P 518035
REPAIR
 A 518004A

ON-SITE SEWAGE DISPOSAL SYSTEM
HOWARD COUNTY HEALTH DEPARTMENT
BUREAU OF ENVIRONMENTAL HEALTH

ADDRESS: 2188 Woodbine Road PROPERTY OWNER: Jack Walsh

MEMORANDUM

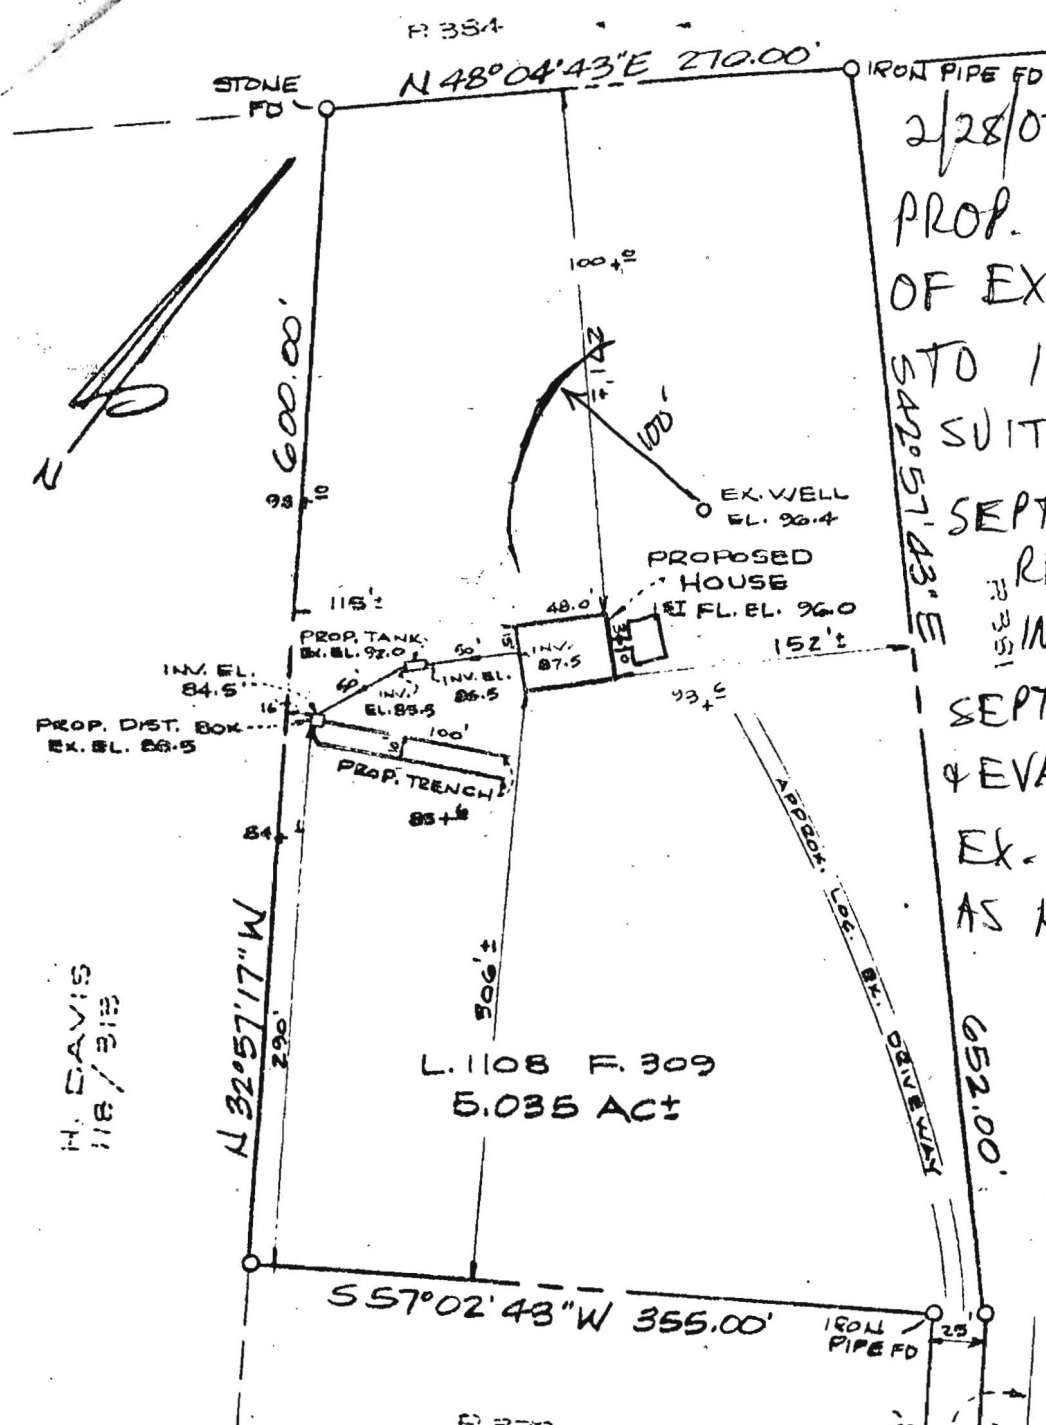
PRE-CONSTRUCTION 1/14/03 Need to locate current trench. If enough room is available between house & ex trench, OK to place new D.B.

INSTALLATION w/ speed breakers between S.T & ex. D.B. - 20' off house, 10' off trench. If not, find ex P.B & place new trench below ex. trenches (S)

1/15/03 - 1st trench being dug, found ex. trench & had room to place new trenches 20' off house (S)

1/15/03 1 1/2 trenches installed, ran out of stone. OK to cover everything except end of 2nd trench & water line (S)

1/17/03 OK to cover all work. Water line sleeved between ex house & remodeled garage

PLOT PLAN
 OF PROPERTY CONVEYED TO
JACK B. WALSH
 L. 1108 F. 309
 SITUATED ON MARYLAND RTB. 94

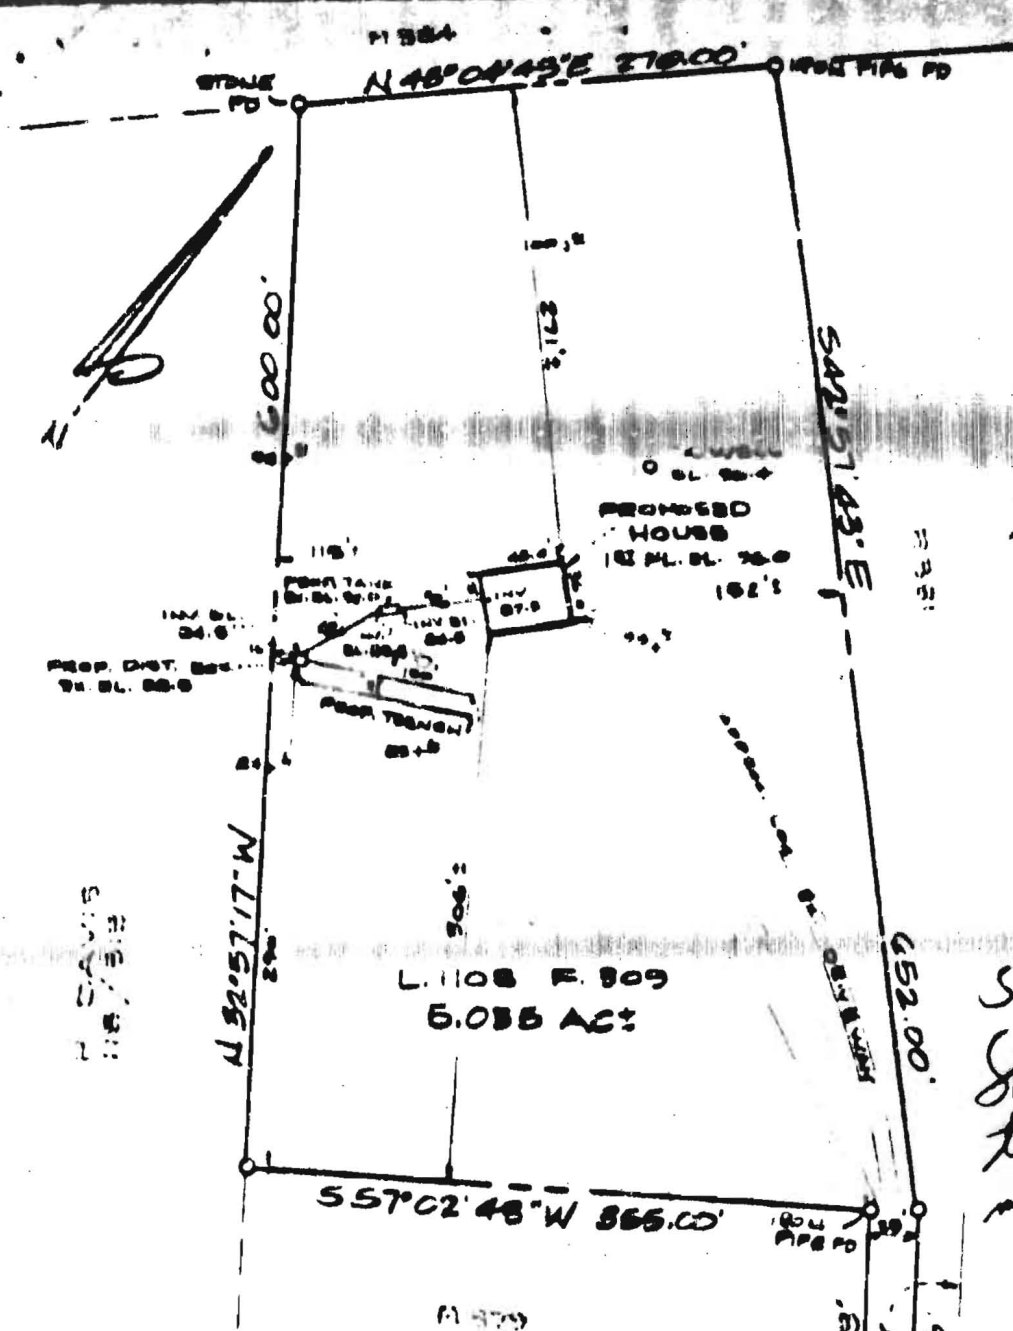
5/25/83
 Sketched OK.
 Track may be
 used to right
 of S

PLOT PLAN
OF PROPERTY CONVEYED TO
JACK B. WALSH
L. 1108 F. 309
SITUATED ON MARYLAND RTE. 94
4th ELECTION DISTRICT
HOWARD COUNTY, MARYLAND
SCALE: 1"=100' MAY, 1983

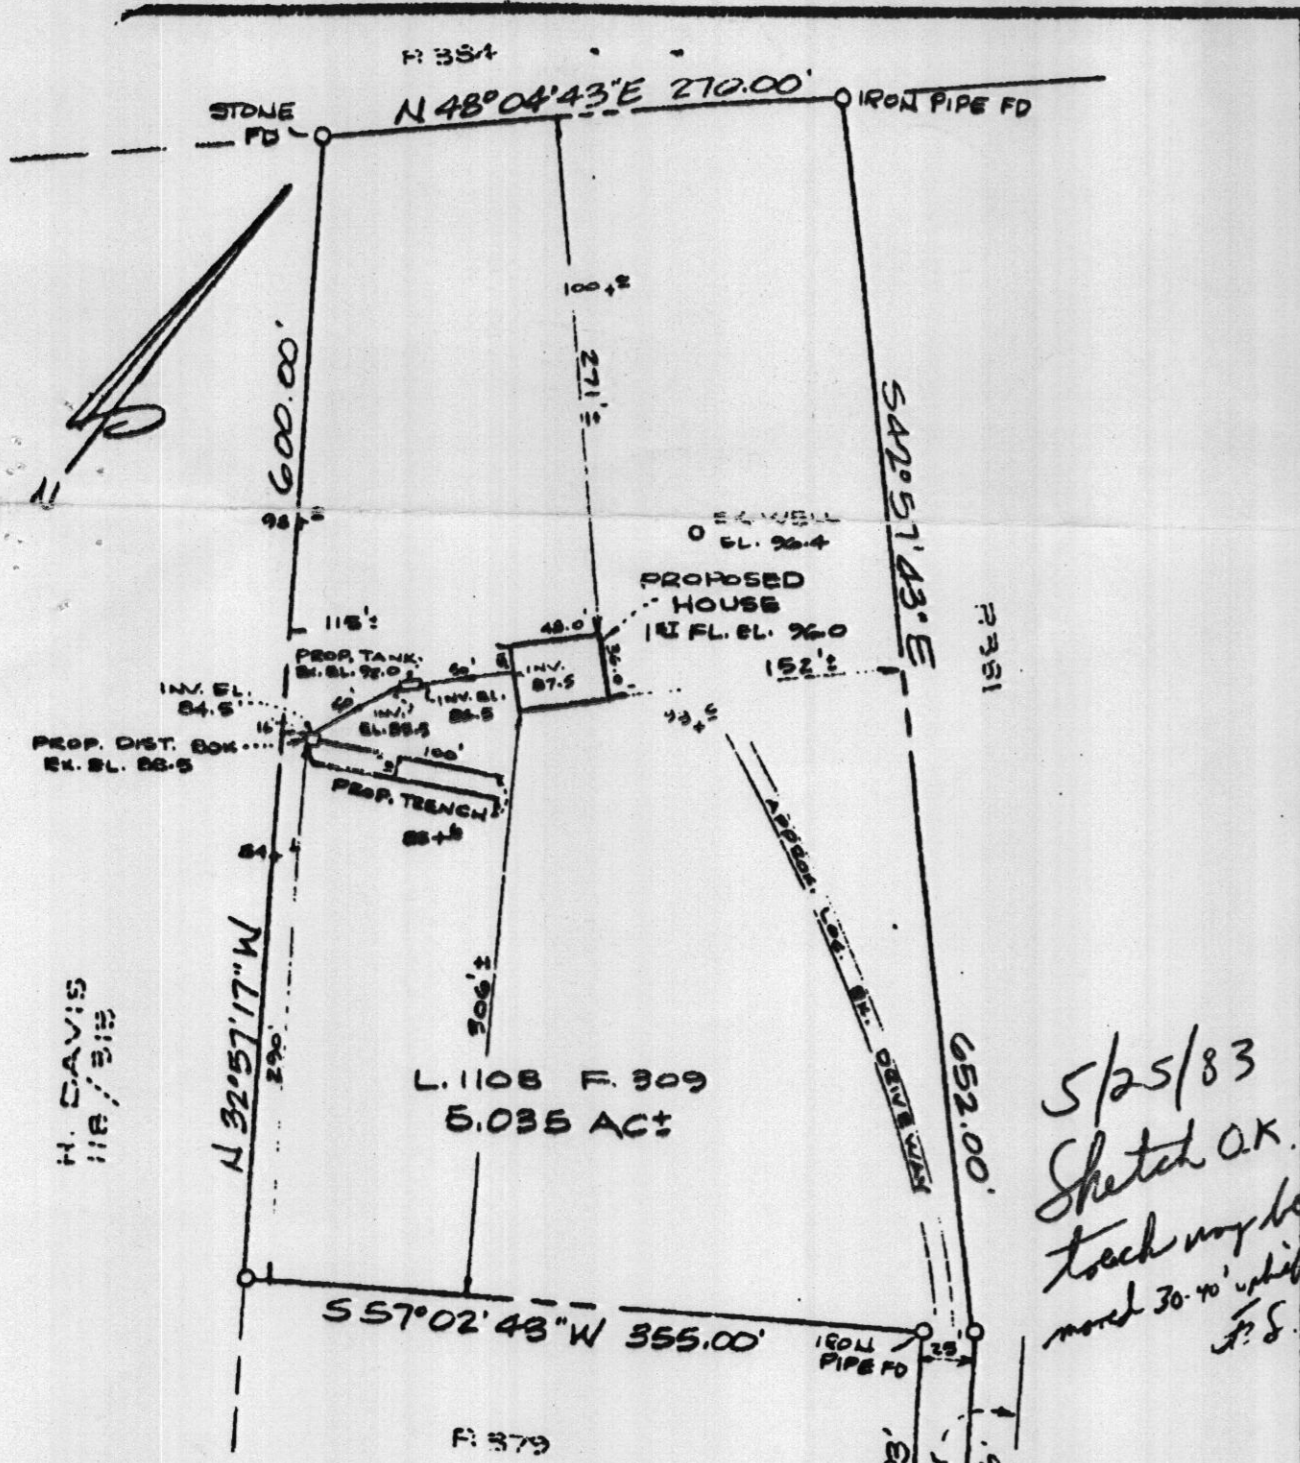
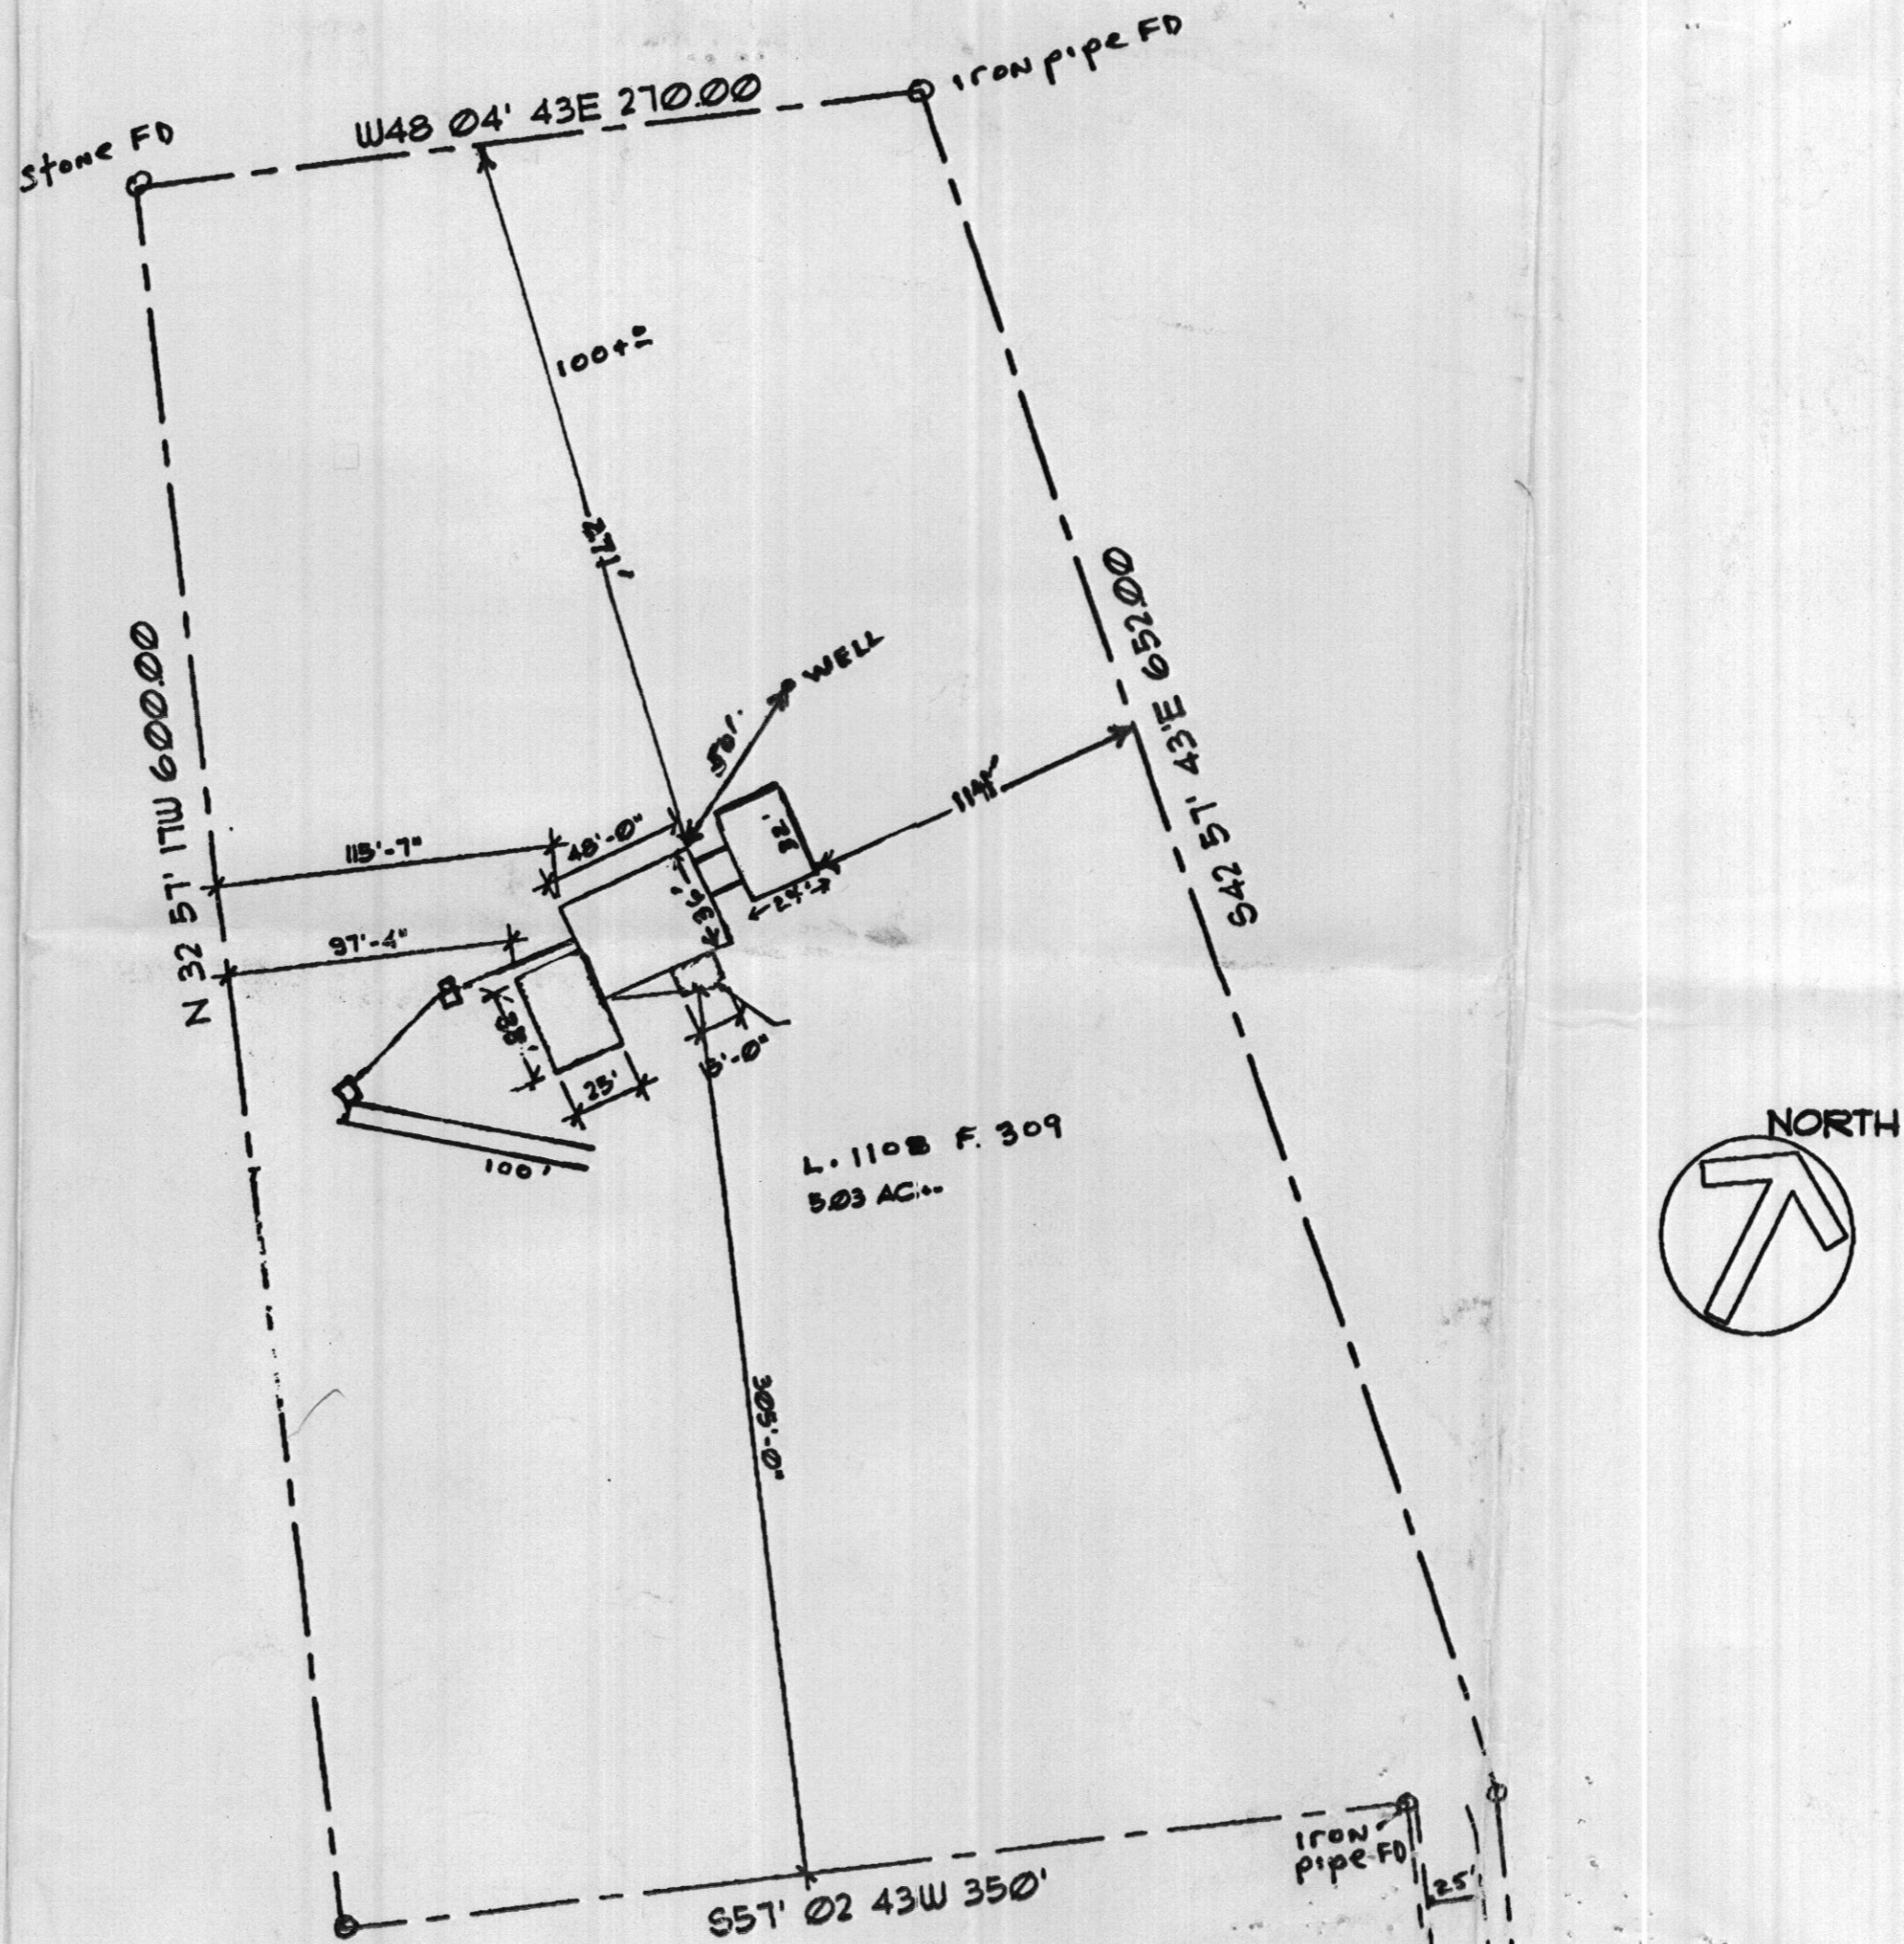
4 x 300 = 1200 total req'd
- 300 credit for 50% ex. system
900
.62
558 ~~7~~ req'd w/new specs
= 3' WIDE = 185'

OK TO REVERT TO 100' TRENCH REQ'MENT AS PREV. DISCUSSED BY J. BORIS
